From: Rye Town Council

**ESCC
1066 Path
Sustrans
England Coastal Path
Rother DC**

Rye Connectivity: Cycleways and Footpaths

Enclosure 2: Rye Neighbourhood Plan – The Greenway proposal

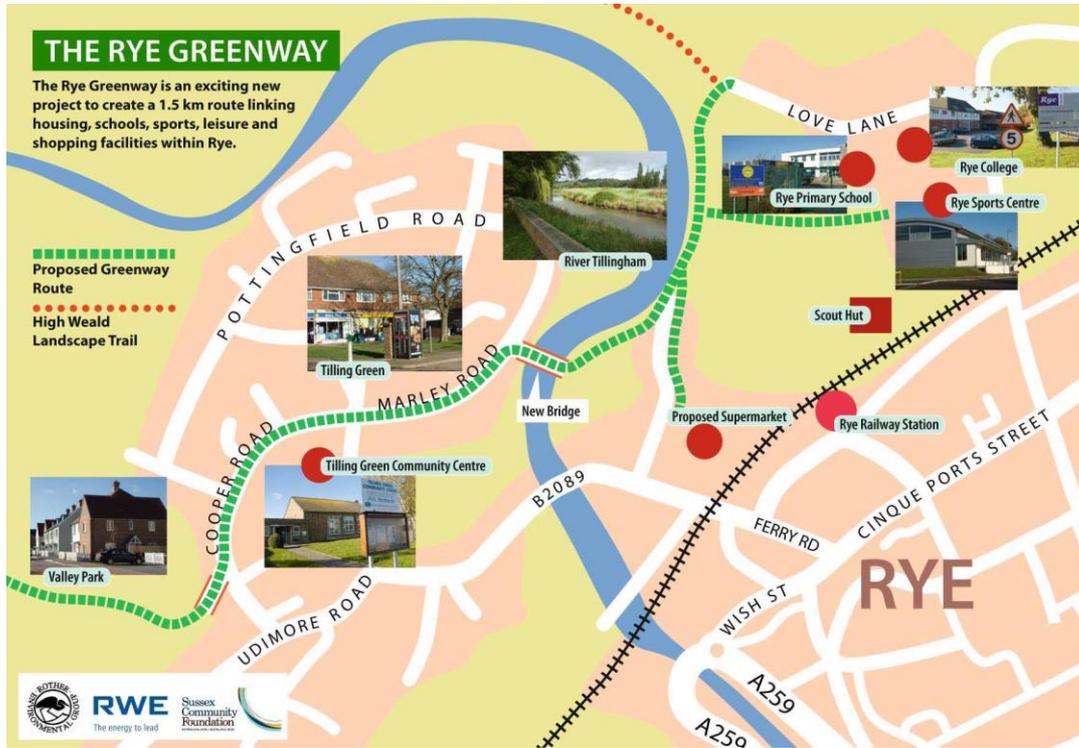
- a. The **Greenway** features in the RNP as a valuable Valley Park to Schools route which has some funding attached that is held by Rother District Council. Sadly, despite significant work here in Rye, the project stalled because ESCC suggested that the costs would be high

and outstanding funds difficult to priorities. At the time ESCC said that Rye just did not attract sufficient priority

This could be facilitated in part by the stalled **Greenway project** (Rye Neighbourhood Plan), for which Rother District Council retains some funds, and would provide via a pedestrian footbridge over the River Tillingham. A route between the majority of the population in the west of Rye and the educational and leisure campus, with onward links to the key hub of the Station Approach; to the Monkbretton Bridge for links to the East; to Rye Hill and the Military Road, would greatly improve safe connectivity in all directions.

Enclosure 3: Rye: Southabout and Northabout East – West Pedestrian and Cycle Routes

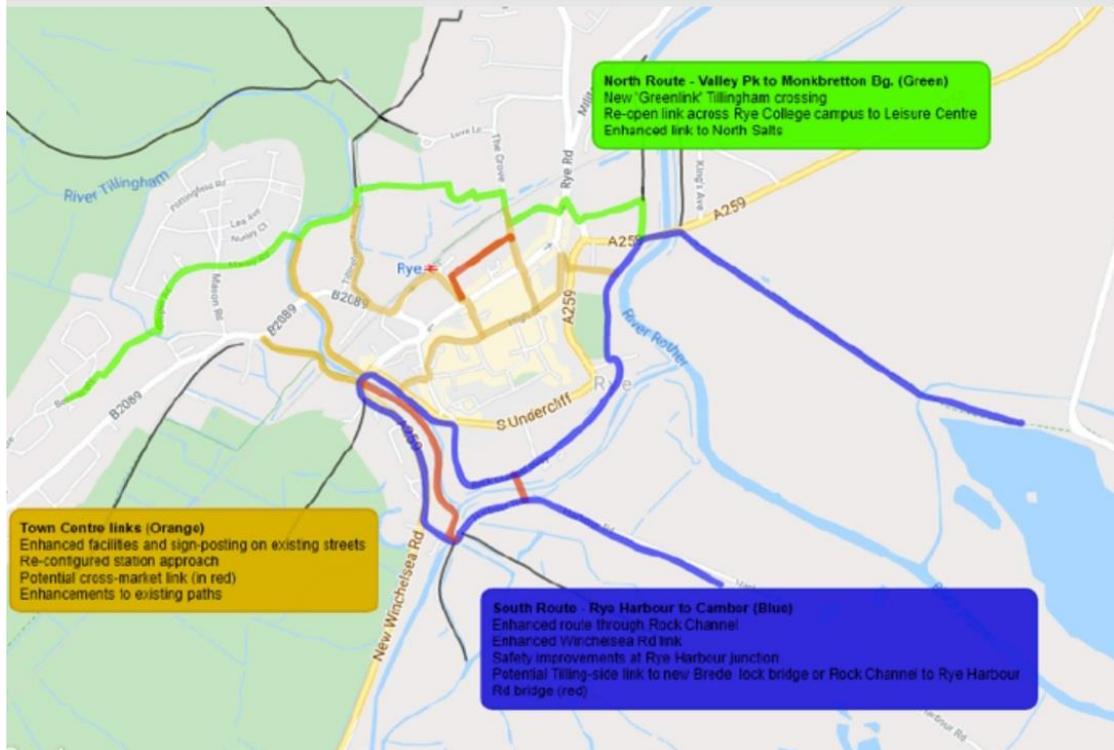
a. The Coastal East-West Path – The Southabout Route

The **Rye Harbour Road junction** with the A259 should be an immediate priority for some improvement as it has been the subject of much public correspondence in recent years. With traffic levels forecast to increase on the Harbour Road because of employment development there the Authorities should re-examine the situation with a view to making change to benefit public safety. We have heard the arguments that there is no justification for changing the current junction but casual viewing at peak hours will show large vehicles mounting the pavements and threatening pedestrian safety. We also know that land

adjacent to the crossing was earmarked for improvements by East Sussex County Council, when it disposed of its former gritting depot. Improvements of the Harbour Road junction could then lead to an enhanced connection between Harbour Road and the Monkbretton bridge which will have the added advantage of allowing the England Coast path to run through Rye as was originally envisaged. This has in part been factored into planning proposals for the Rock Channel.

b. The East West Connections within Rye : The Northabout Route

Valley Park to Camber (Route 3) of the current ESCC initiative.
